6/24/14	Added New Sheet.
DATE	REVISION
STATE OF HAWAII DEPARTMENT OF TRANSPORTATION HIGHWAYS DIVISION	
WATER POLLUTION & EROSION CONTROL NOTES	
HALEAKALA HIGHWAY INTERSECTION IMPROVEMENTS AT KULA HIGHWAY Project No. 37C-01-14	
Date: June, 2014	
SHEET No. 1 OF 3 SHEETS

6/24/14	Added Notes.
DATE	REVISION
STATE OF HAWAII DEPARTMENT OF TRANSPORTATION HIGHWAYS DIVISION	
TYPICAL SECTIONS & DETAILS	
HALEAKALA HIGHWAY INTERSECTION	
IMPROVEMENTS AT KULA HIGHWAY	
Project No. 37C-01-14	
Scale: As Shown	Date: April, 2014
SHEET No. 1 OF 3 SHEETS

DEMOLITION PLAN

**HALEAKALA HIGHWAY INTERSECTION
IMPROVEMENTS AT KULA HIGHWAY**

CURB RAMP PLANS

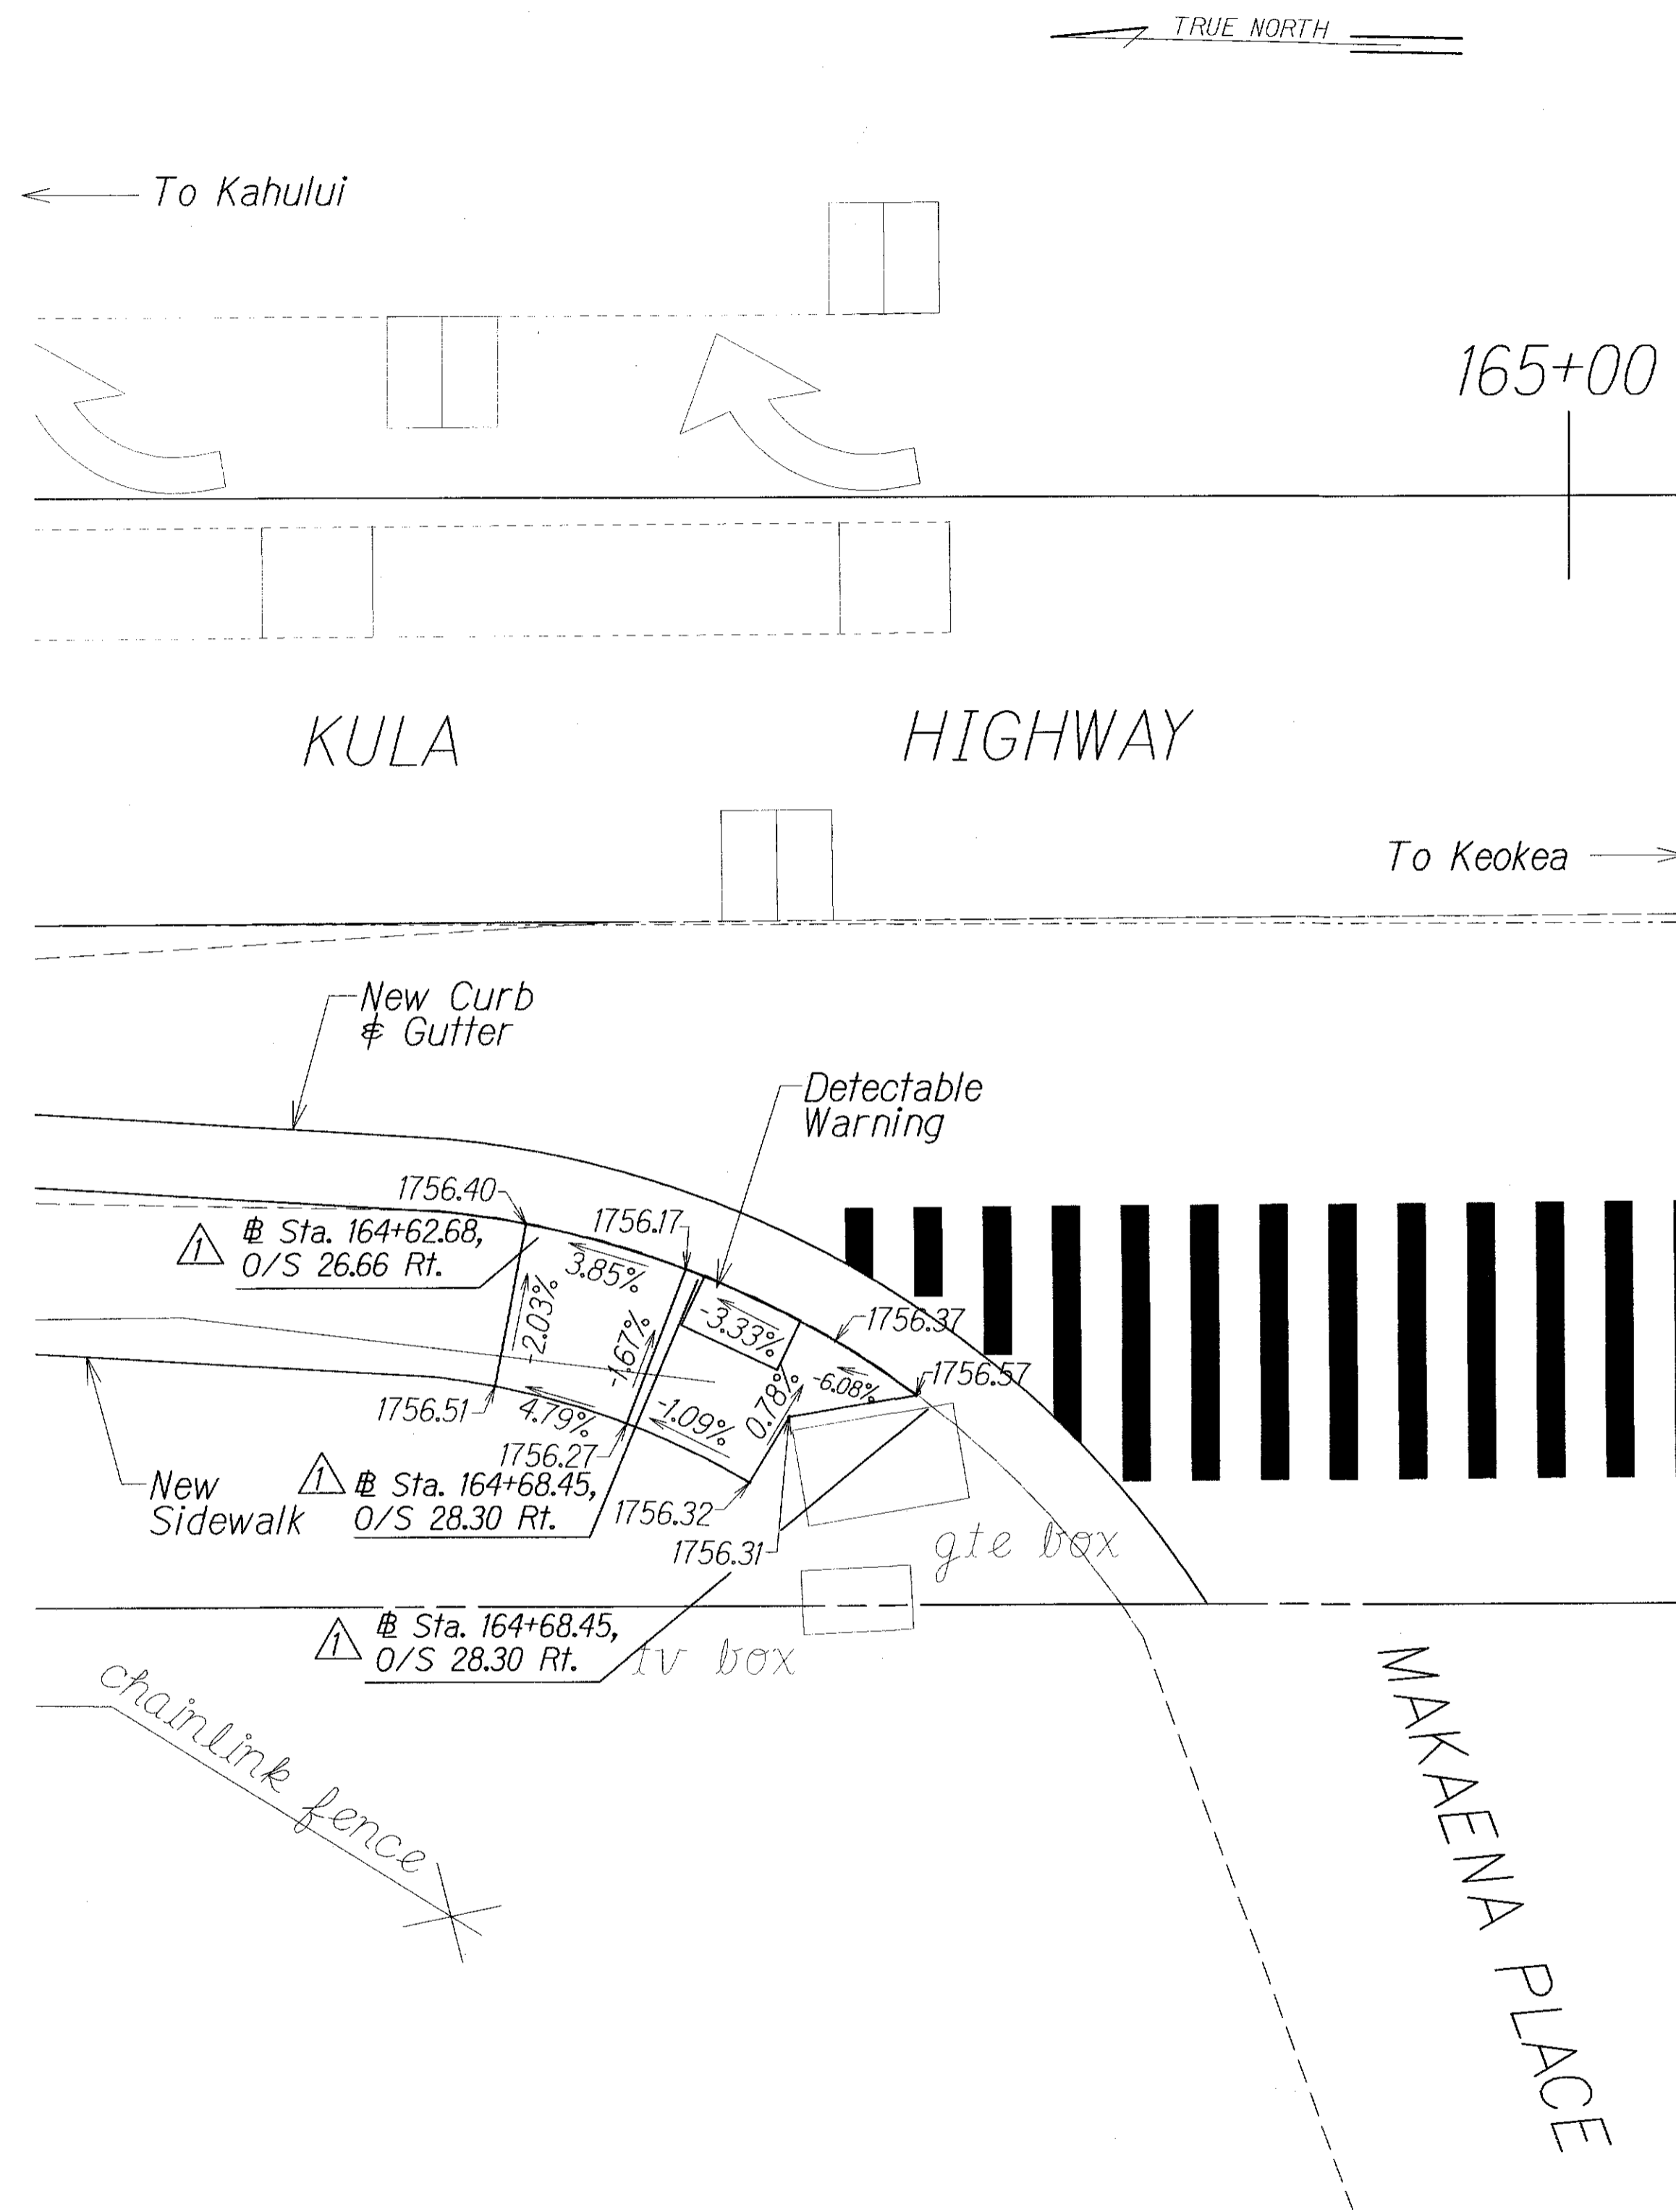
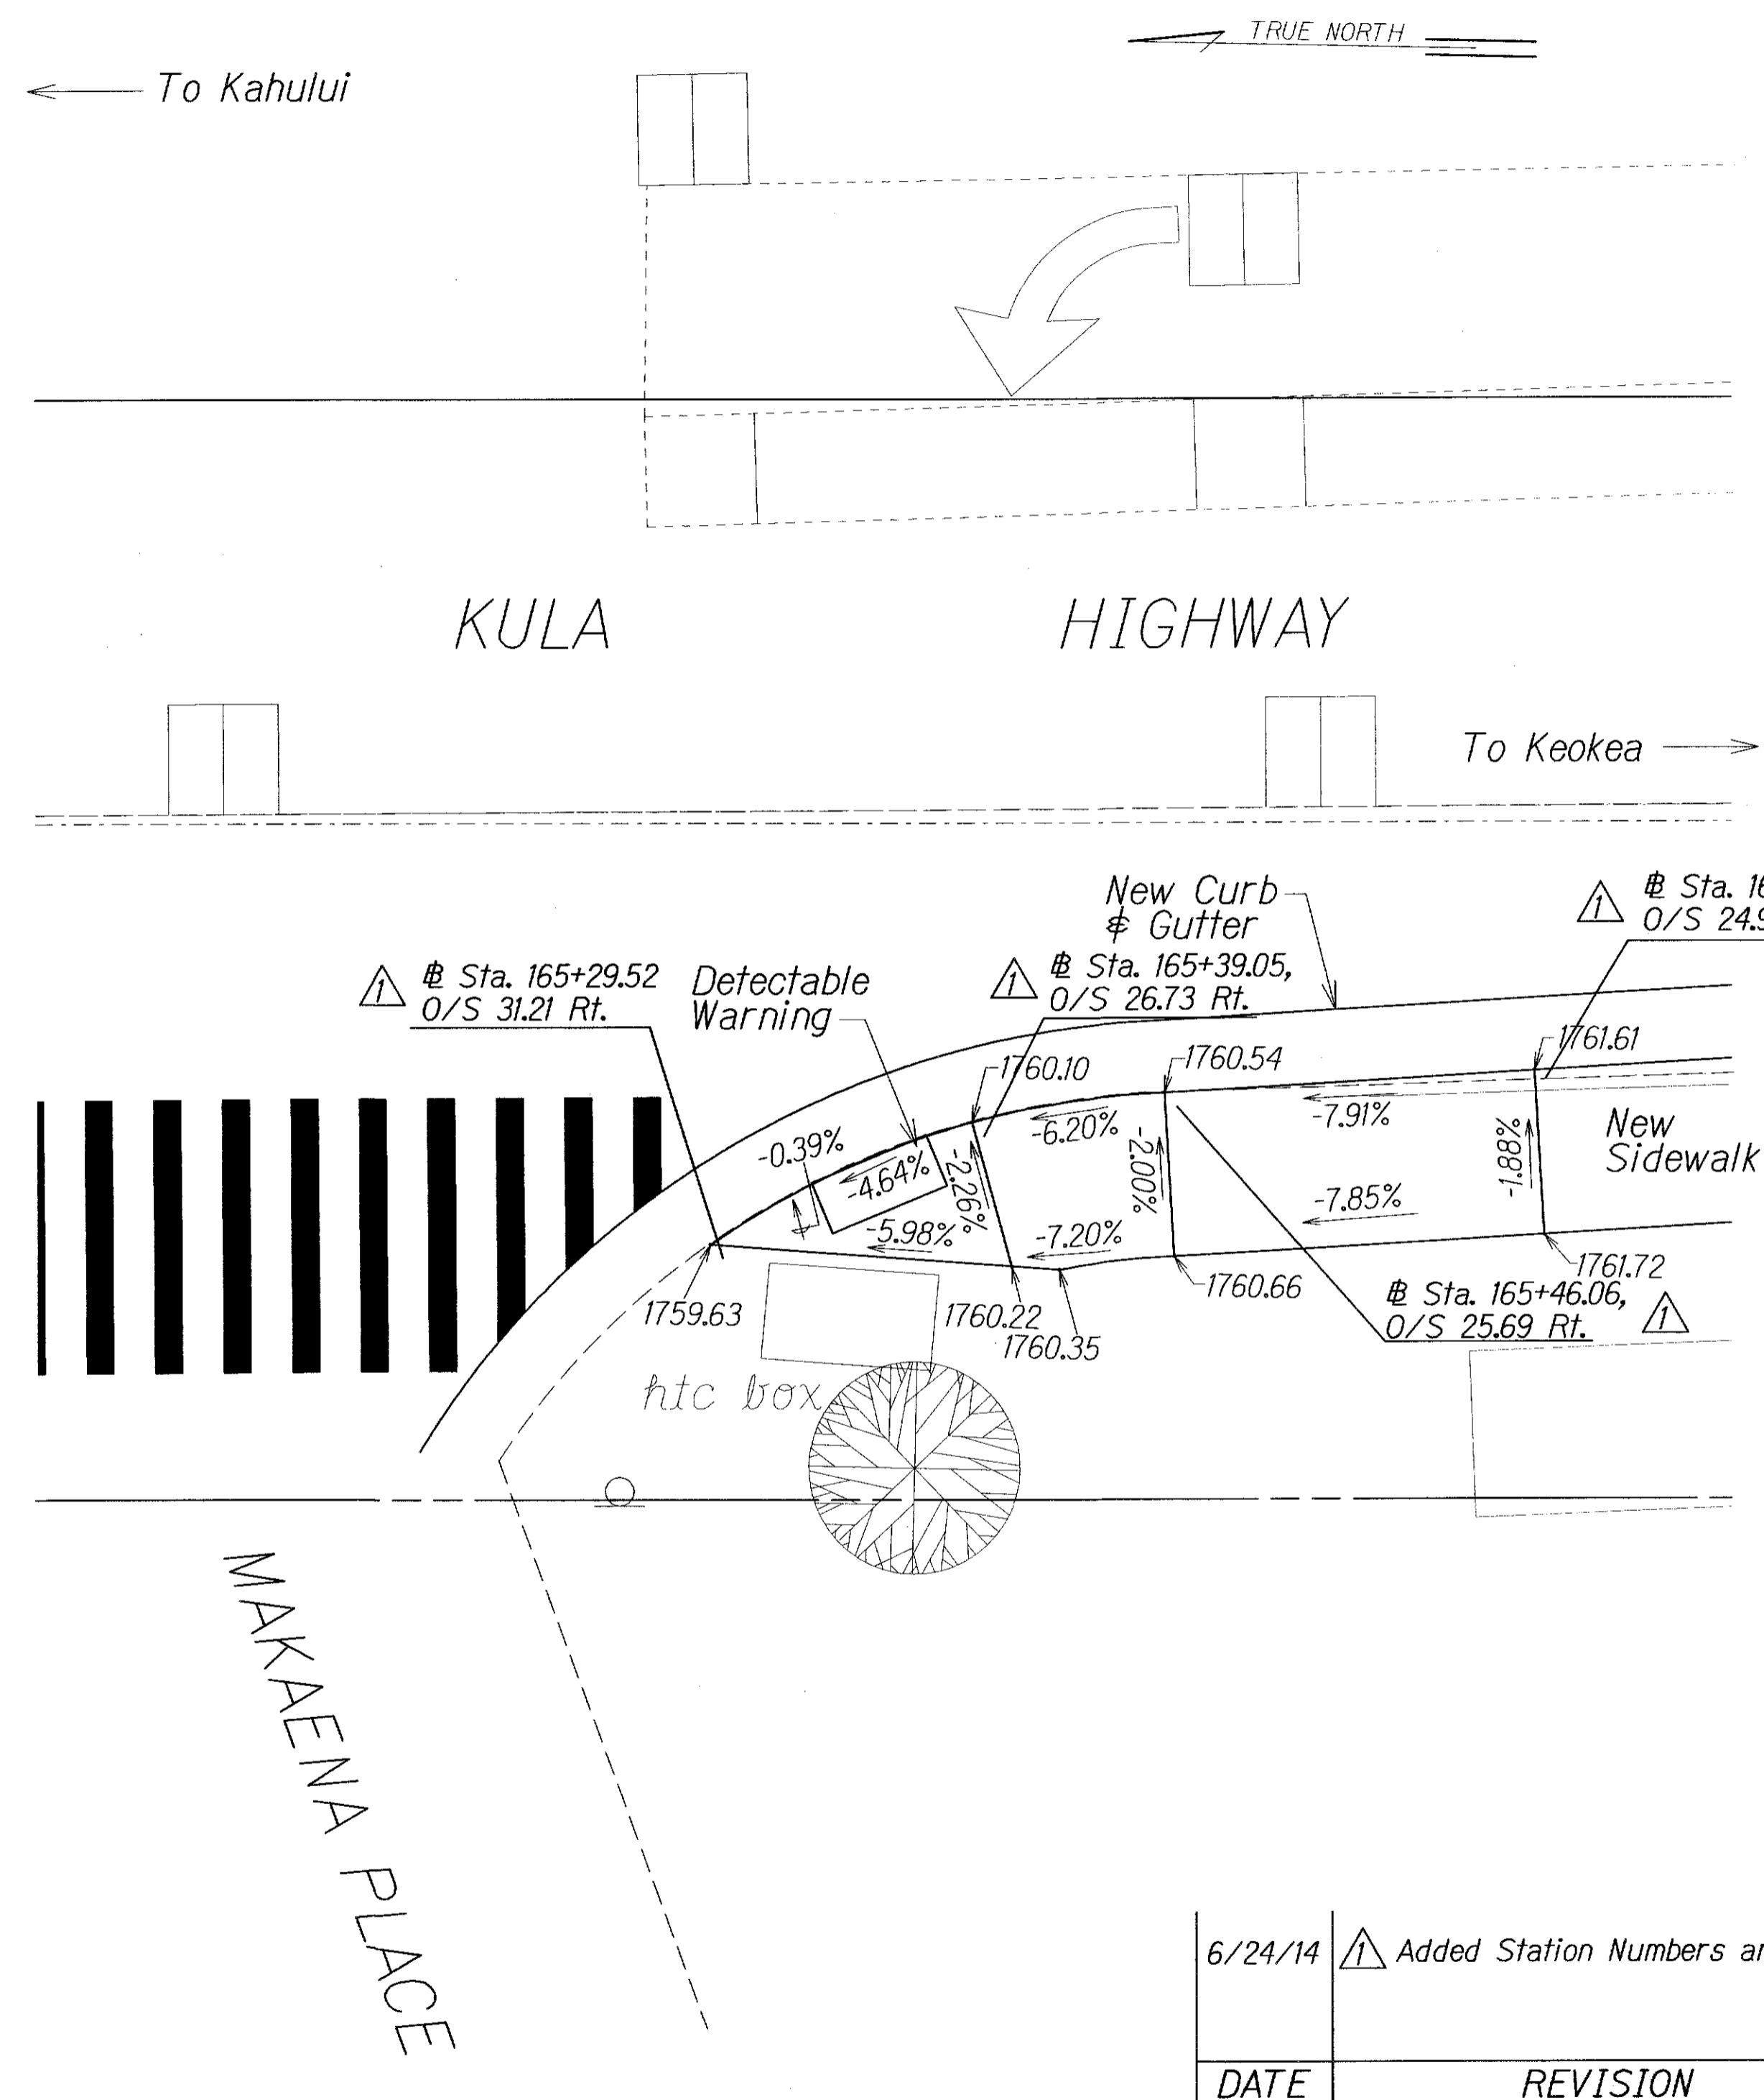
6/24/14 **Added Station Numbers and Offsets.**
